PLANNING COMMISSION AGENDA

Subject: PC 12-29 JH Architects, Site Plan Dayton Freight Lines

TO: Scott Harlicker, City Planner
FROM: Bob Moberg, City Engineer
SUBJECT: Revised Site Plan Review – Dayton Freight
DATE: March 14, 2013

SHEET NO.
SP1

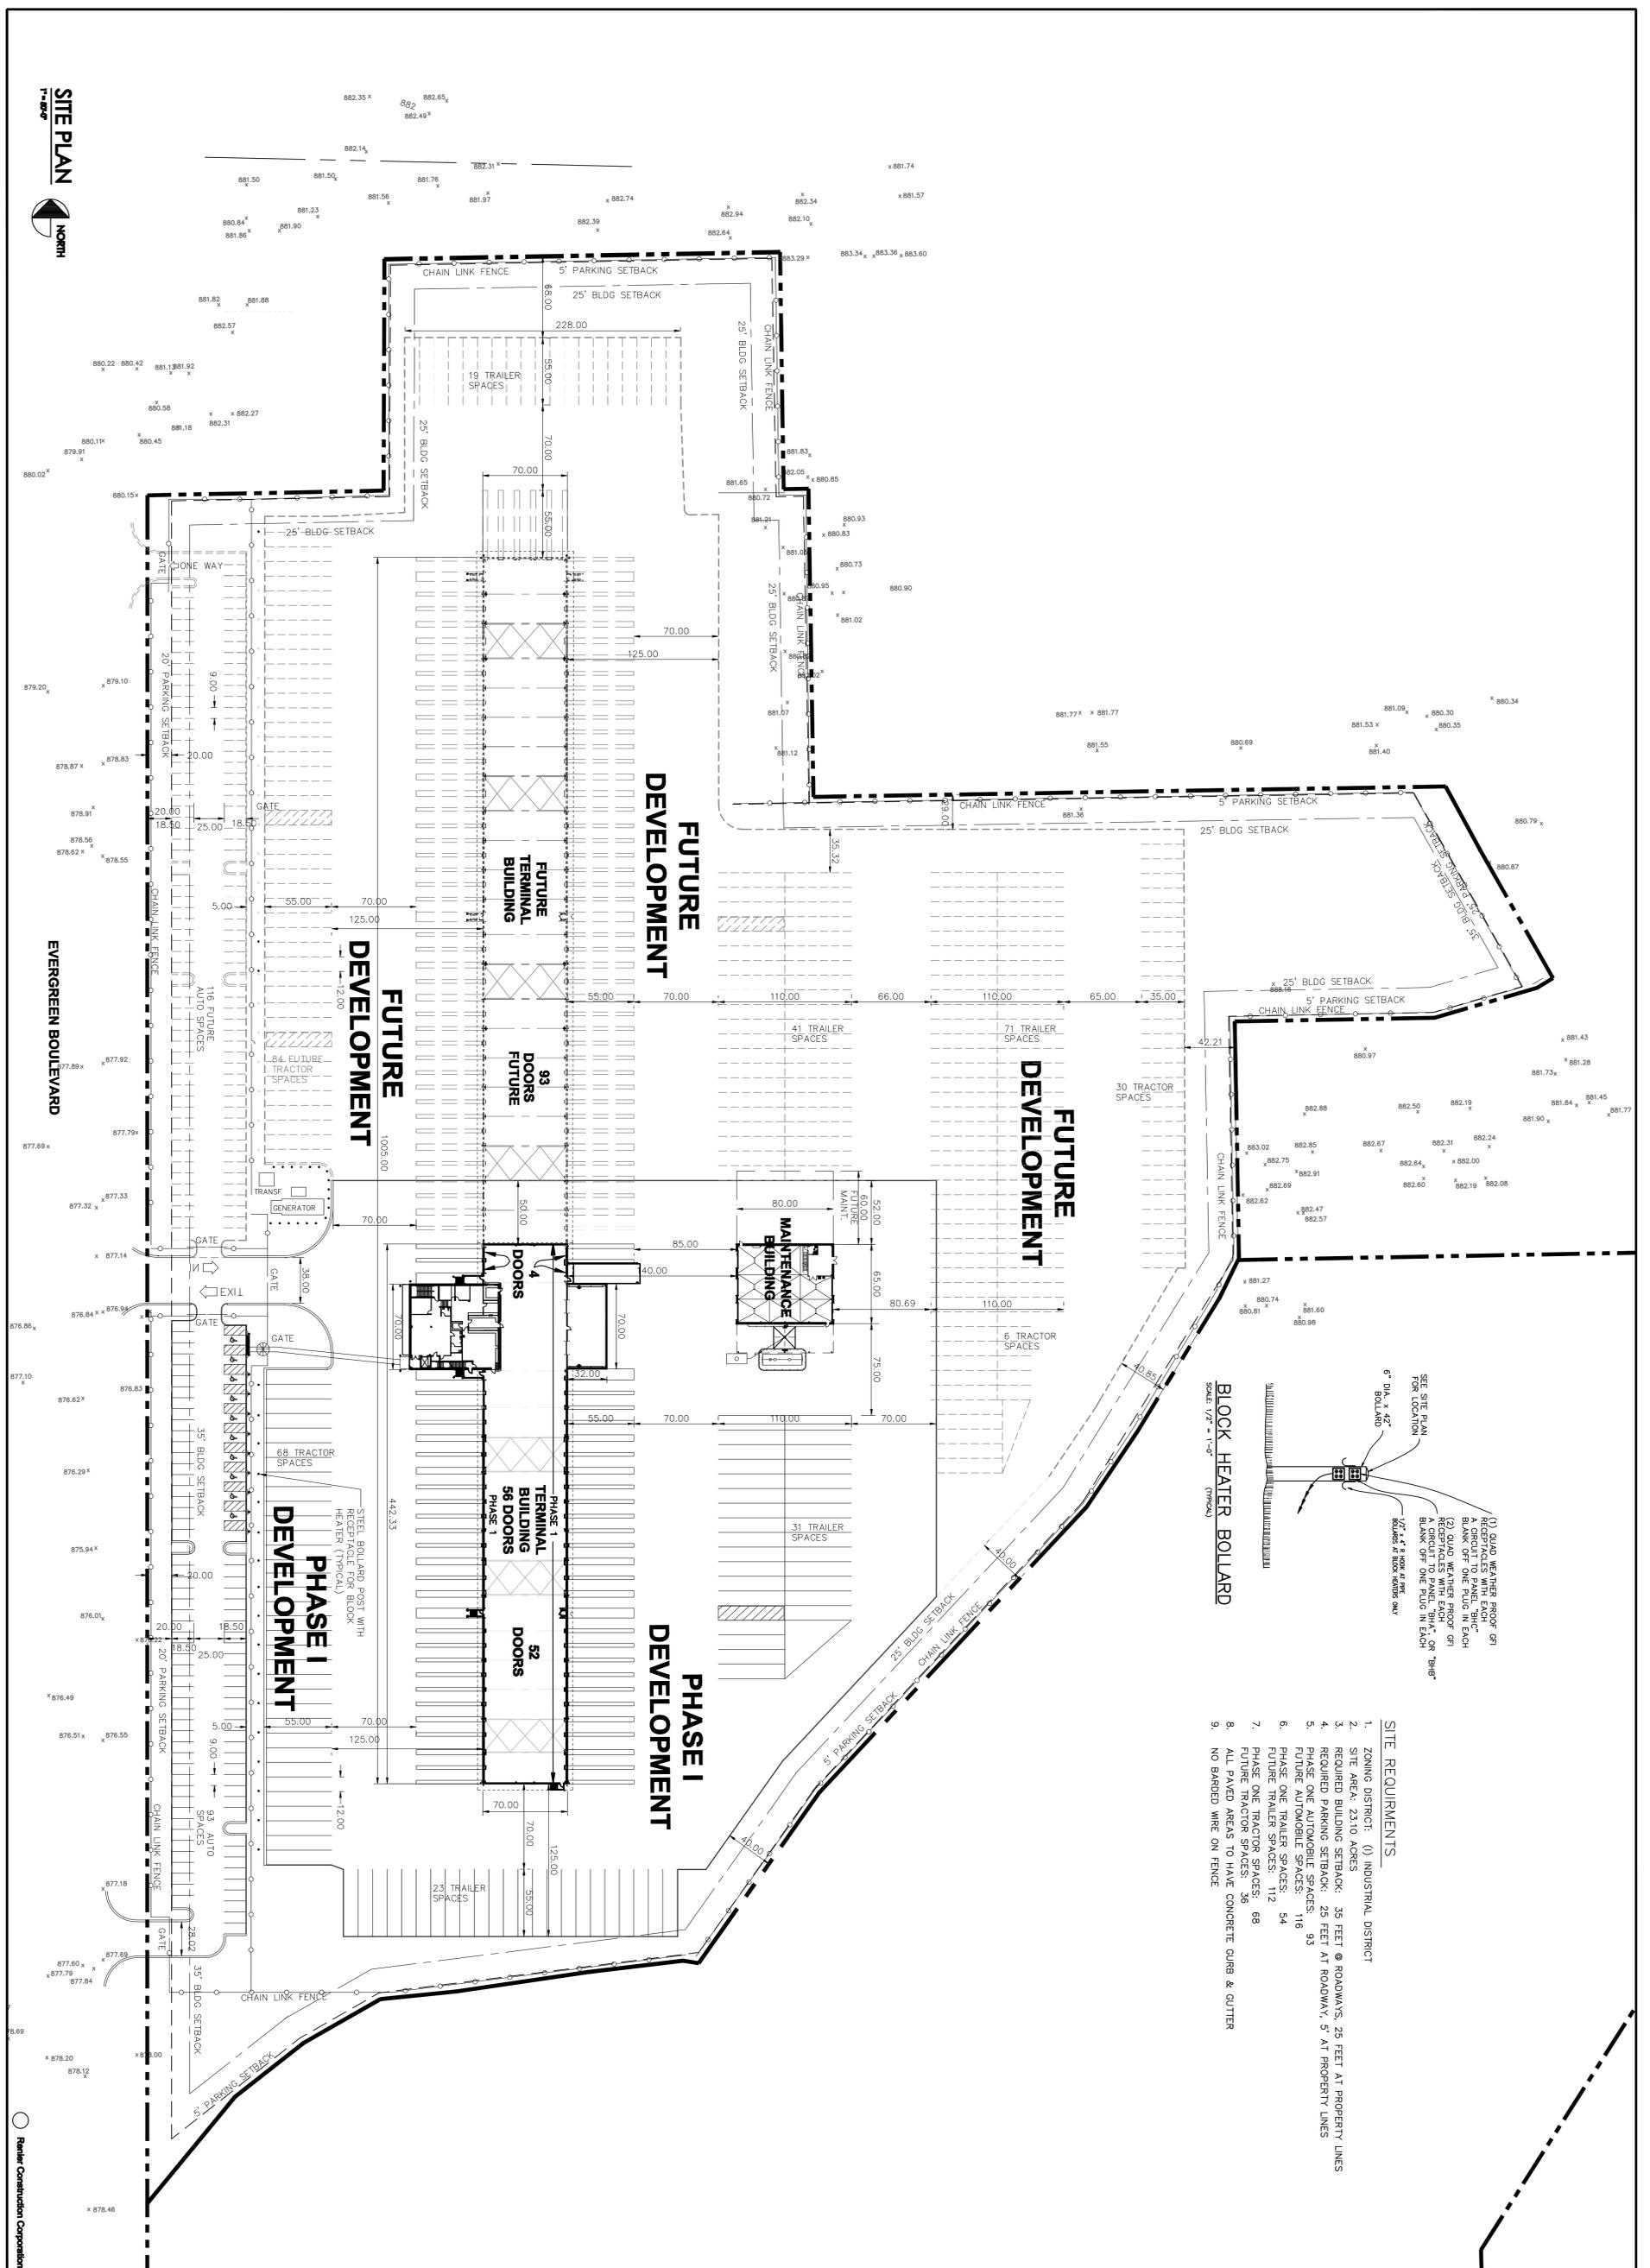
Changes have been made to the site plan that improve screening, the phasing has been changed, and the size of the maintenance facility has been reduced and its location moved. A traffic study has been completed and its findings incorporated into the recommendation. An analysis of the changes is included in the following discussion:

2. The applicant shall furnish evidence, using truck turning templates, that the median openings in Evergreen Boulevard at the site entrances are wide enough to accommodate truck turning movements. If the openings are too narrow, modifications to the median islands and related storm sewer structures will be required.

3. Commercial concrete driveway aprons are required at all entrances to the site from Evergreen Boulevard.
4. Drainage calculations must be submitted for onsite drainage improvements to demonstrate compliance with City and Coon Creek Watershed District requirements for storm water rate and volume control and for phosphorus and sediment removal.

1. Park dedication in the amount of \$92,400.00 must be paid prior to the issuance of a building permit.
2. Compliance with Title 11 of the City Code.
3. No access is permitted to Outlot F or Springbrook Drive.

6. Concrete curb and gutter must be installed around the perimeter of all paving, landscaped islands, medians and peninsulas.
7. The use of barbed wire is prohibited.

8. All comments of the City Engineer and Fire Department must be addressed to their satisfaction.
9. The generator and transformer located at the main entrance must be moved to the rear of the terminal building.

DAYTON FREIGHT
COON RAPIDS, MN
PREPARED FOR:
JH ARCHITECTS
FINAL LANDSCAPE PLAN

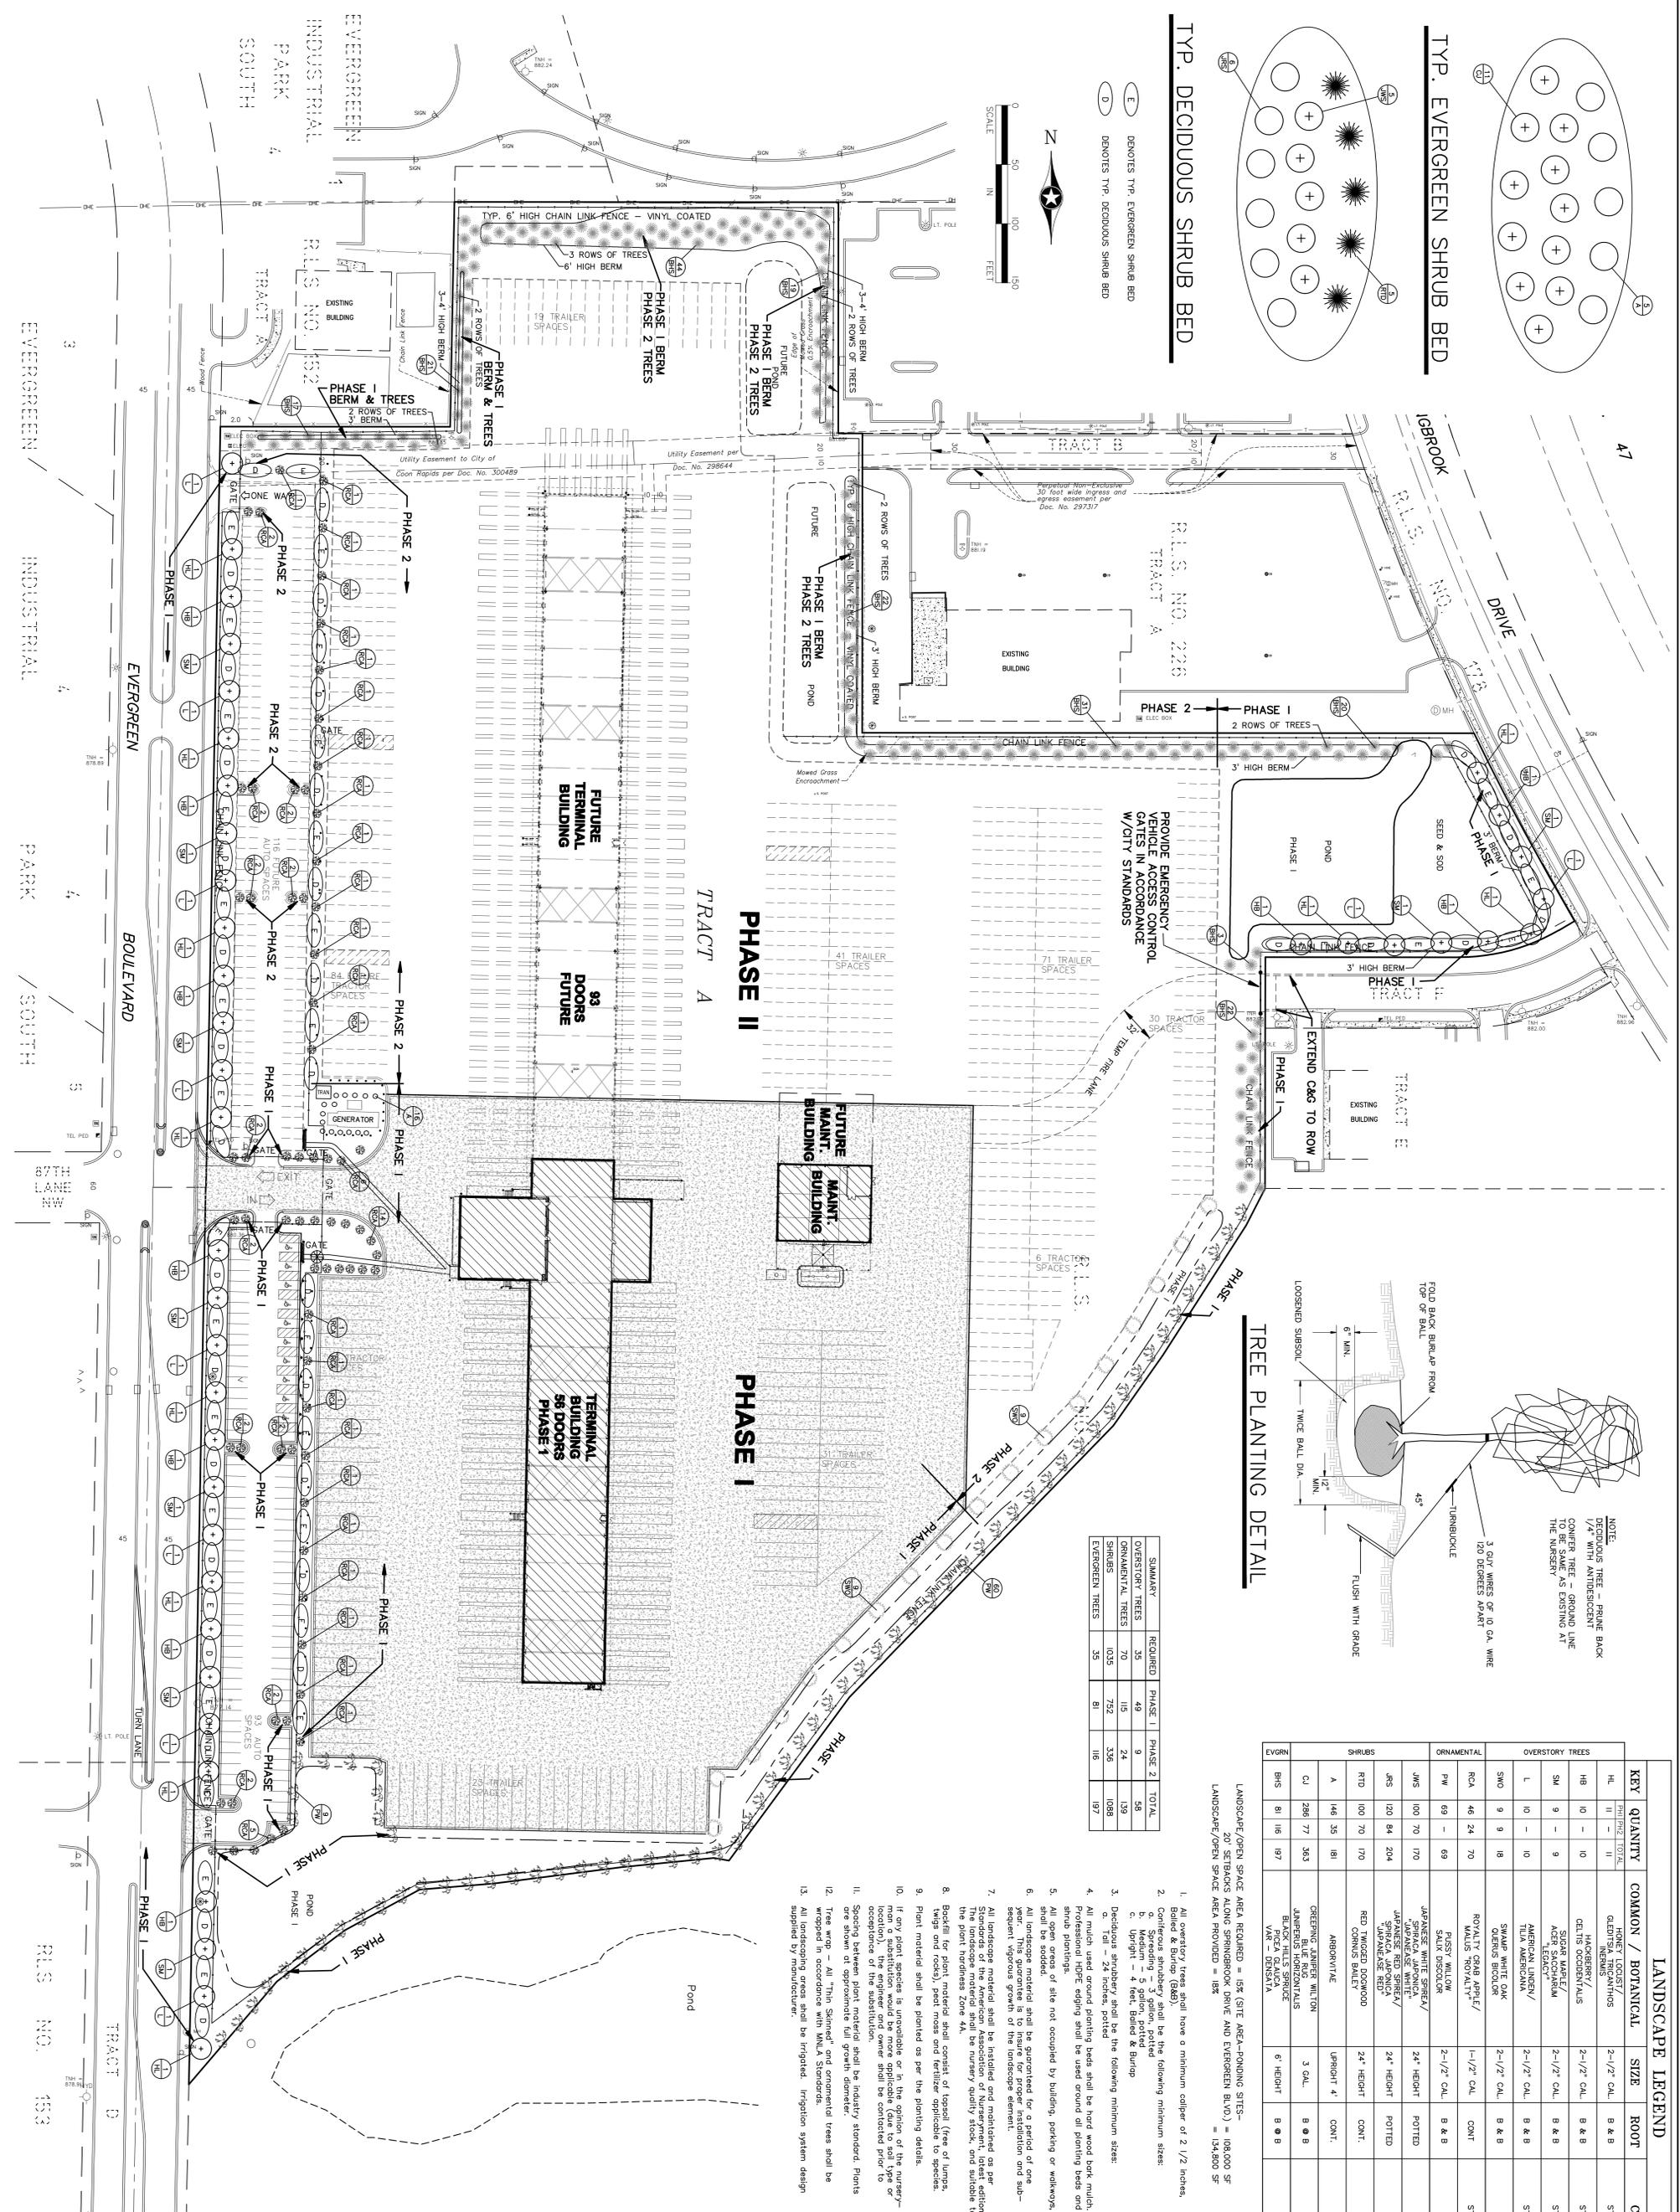
(8) Show sufficient landscaping	NO – Street frontage landscaping meet code. However, the open space landscaping plan is short on overstory trees and shrubs. See landscaping discussion and table.

The landscaping plan has been revised to include additional berming and landscaping along the adjacent uses to the north. The berm along the north property line, adjacent to the YMCA has been widened and the height increased to six feet. The other berms remain at three feet. The landscaping plan has been amended to include shrubs and ornamental trees in the median between the automobile parking and the freight yard. The southeast property line has been planted with a mix of pussy willows and oak trees. The berm adjacent to the YMCA has been planted with three rows of evergreens. The entrance into the facility has been planted with ornamental trees.

The landscape plan exceed the requirements for ornamental trees (139 proposed and 70 required) and evergreen trees (197 are proposed and 35 are required), but is short on overstory trees (24 proposed and 35 required) and shrubs (416 proposed and 1035 required). Staff is recommending that the additional evergreen and ornamental trees be counted toward meeting the open space requirements for overstory trees and shrubs.

13. The landscaping on the north property line, adjacent to the YMCA, must be shifted to the south so that they are not within the utility easement.
14. The that the additional evergreen and ornamental trees be counted toward meeting the open space

requirements for overstory trees and shrubs.
